# 5. HDMI BLOCK

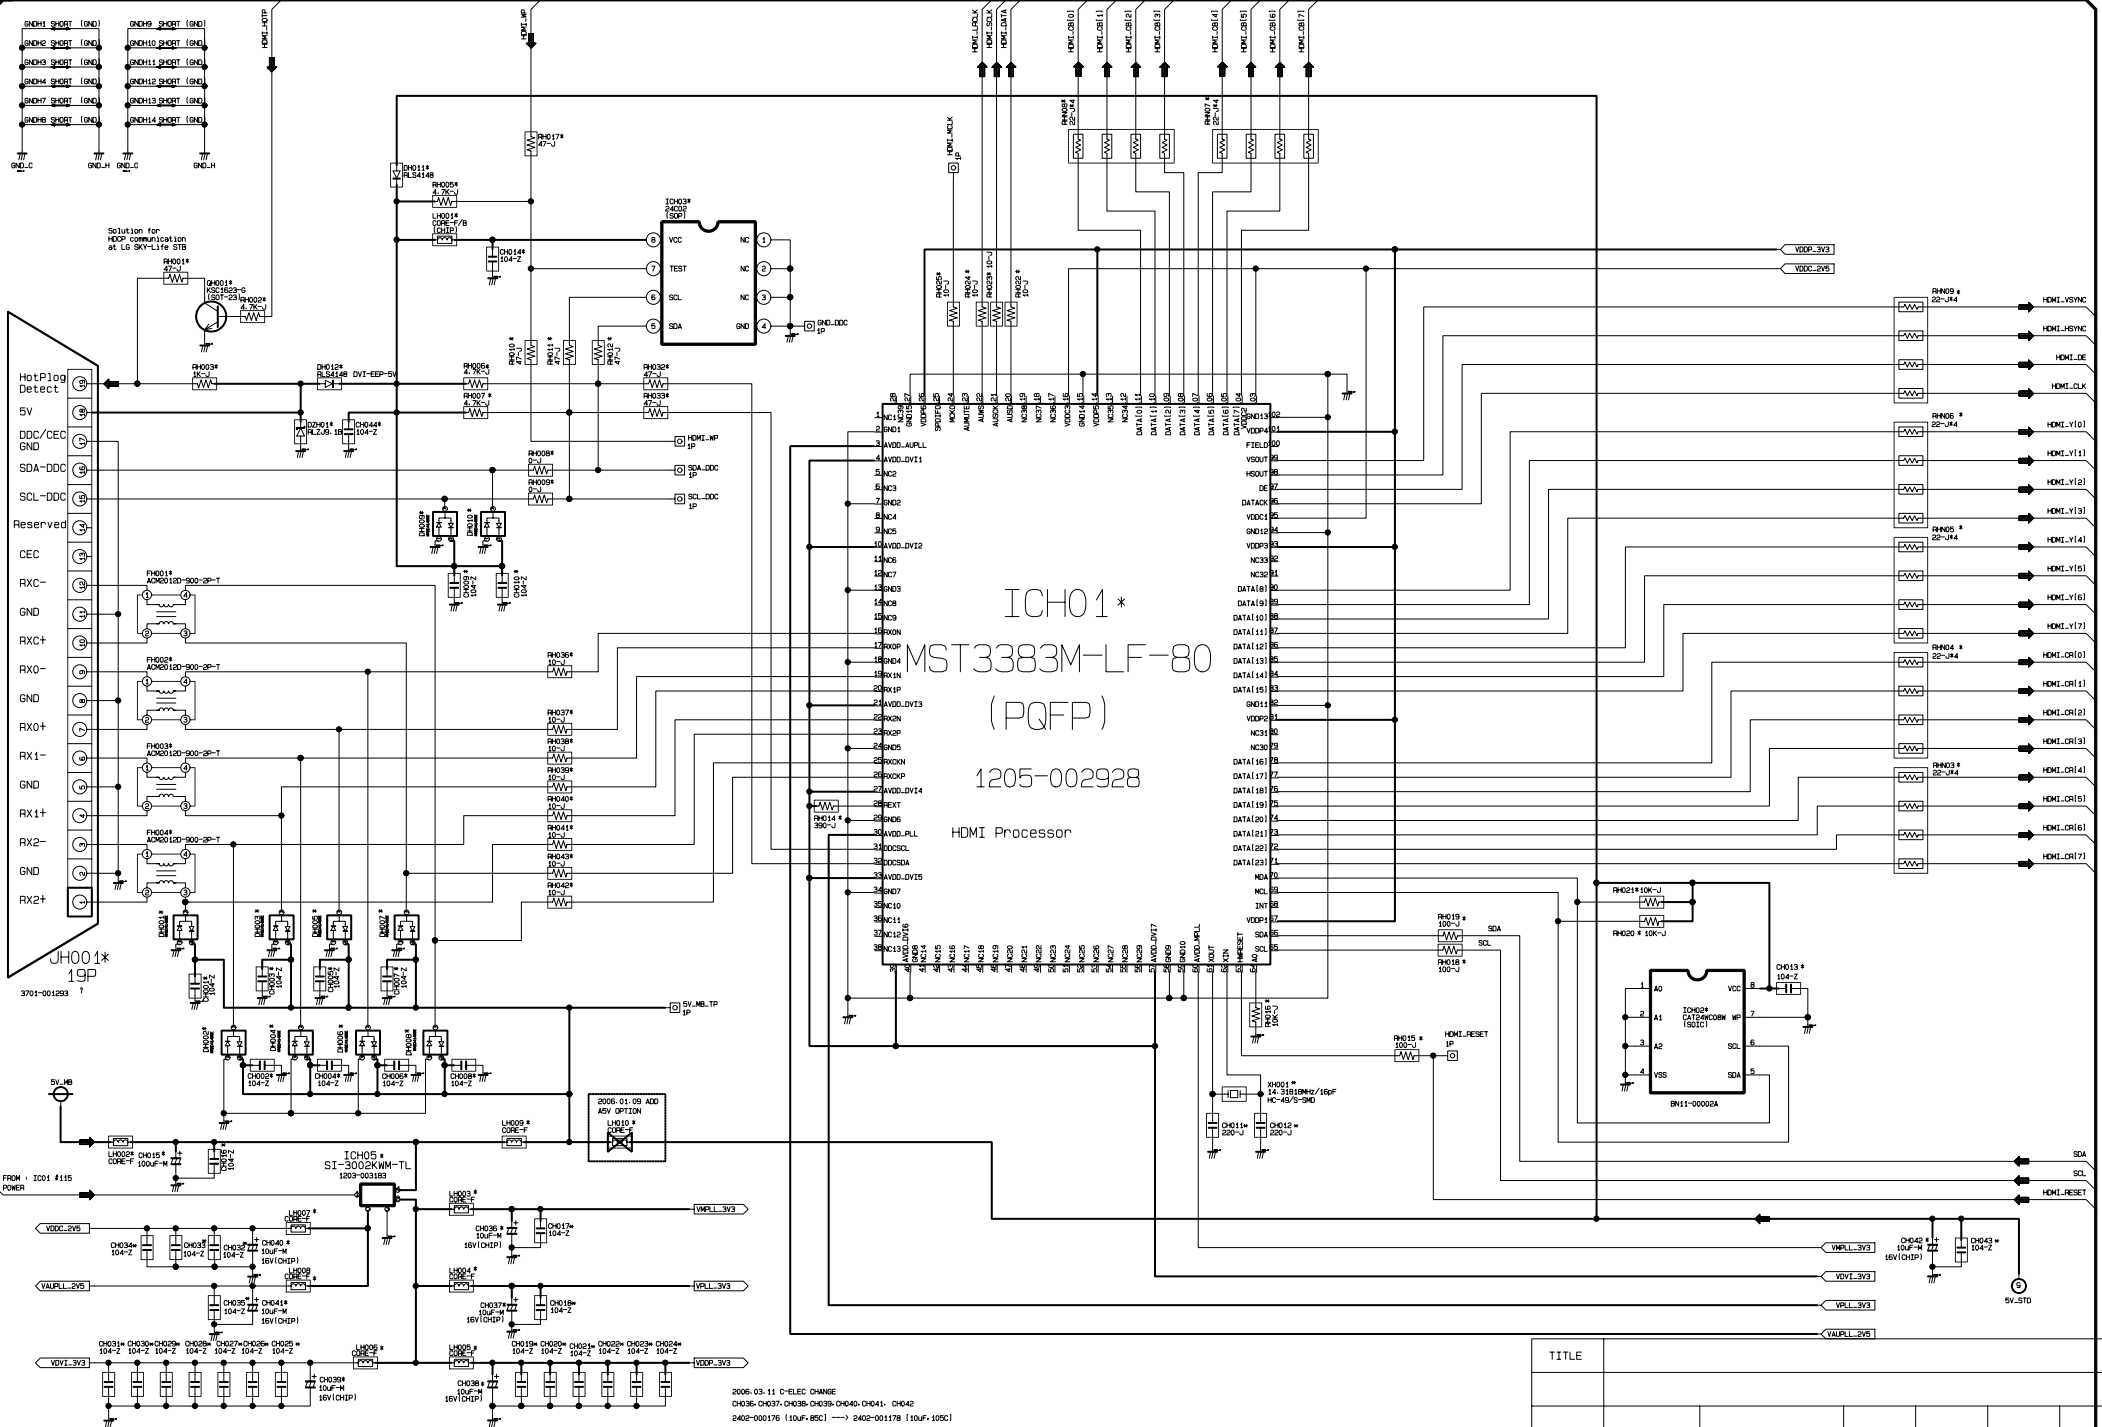
2006-03-11 C-ELC CHANGE  
CH036, CH037, CH038, CH039, CH040, CH041, CH042  
2402-000176 (10uF, 85C) -> 2402-001178 (10uF, 105C)
